## THE PURPOSE OF ADDENDUM IS TO <u>MAKE CHANGES</u> AND P<u>ROVIDE ANSWERS TO THE REQUEST FOR</u> <u>CLARIFICATIONS</u> TO THE RFP DOCUMENTS.

- Re: RFP No.: 622-005 Campus Center Roof Replacement Rockville Campus
- Attn.: Procurement Office Montgomery College 9221 Corporate Boulevard Rockville, Maryland 20850

ADDENDUM NO. 4 PRICE PROPOSAL FORM REVISED ON 2/9/2022

## Campus Center Roof Replacement Rockville Campus

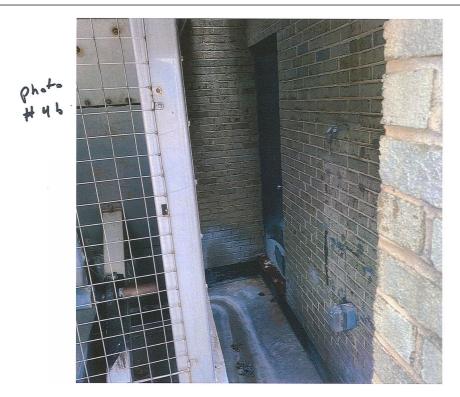
- (7) Question: Condenser unit set on Pad set on roof will require disconnect and reconnect when new roof system is in place. See photo #3a & #3b.
  - Answer: Contractor to include cost of disconnecting and replacing unit as detailed in the drawings. Protection as required by the membrane manufacturer for surface bearing units will be required.
